Stormwater RFI Responses - Rocklea Lines Training Facility

To Ray Carey
From Kripa Paudel
Date 31 March 2026
RE Facility Brisbane City Council RFI re. Development Application for Powerlink Rocklea Lines Training Facility

Figure 1: LCMITF project site location, showing the proposed land disturbance area (red hatched) and lot boundaries (red dashed). Reproduced from the original source: Aurecon, 2025.

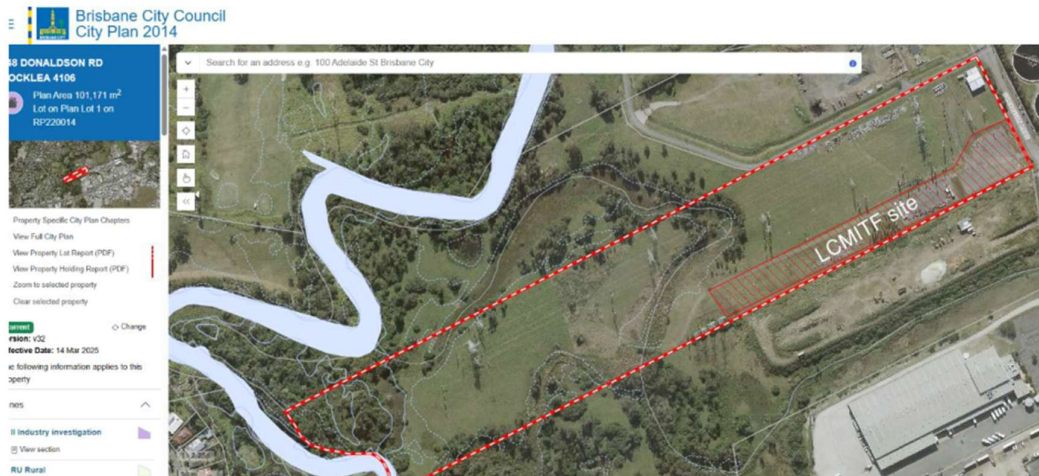
Brisbane City Council (Council) has submitted a Request for Information to Powerlink (RFI) for the proposed development at Lines Training Facility at 148 Donaldson Road, Rocklea, Queensland regarding the S82 change.

The lot area of the proposed development at 148 Donaldson Road, Rocklea is approximately 101,171m². A 2025 report (Aurecon, 2025) addressing section 81 (s81) changes showed that the total land disturbance area associated with the works to be 14,000m².

No change has been proposed to the total land disturbance area associated with the development, the lot area, or the total (existing and new) impervious areas since the s81 application in 2025. Table 1 below has been reproduced from the Stormwater Management Plan (pitt&sherry 2025) completed for the section 82 (s82) application. It shows 13,700 m² as the total land disturbance area (compared to the 14,000m² that was included for s81).

Figure 2: Impervious areas. Reproduced from the original source: Aurecon, 2025.

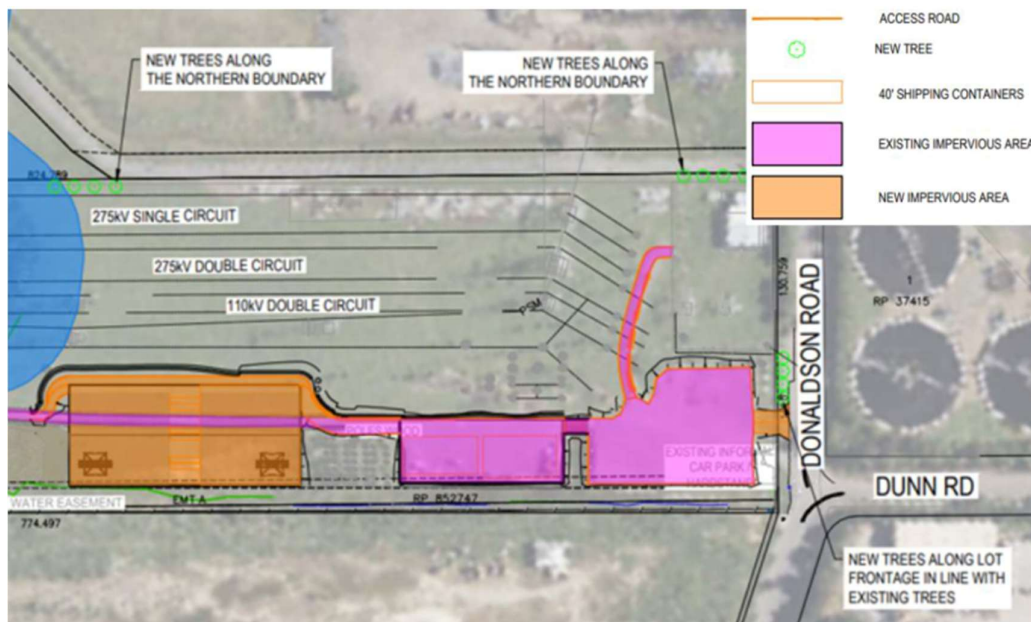
Council's RFI centres around demonstrating compliance to Section B of the Stormwater Code (Brisbane City Plan 2014), unless it can be shown that the code does not apply. Section B is contained within section 9.4.9 of the Code and is triggered per the provisions below:

that application included “Earthworks (cut and fill) associated with providing a building pad and car park for the future second training facility”. S82 change only involves sealing of the existing gravel carpark (central pad in pink as per Figure 2). It was determined that this carpark is impervious in existing situation and agreed with Council so there is no change to impervious area between previous application and s82.

The existing impervious area at the location of proposed development is approximately 6,200m². The changes proposed in the development application for the proposed Lines Training Facility at 148 Donaldson Road increases the impervious area by an additional 3,860m². This results in the total (existing and new) impervious area for proposed development to be approximately 10100m², or 9.9% of the total 101,171m² lot area.
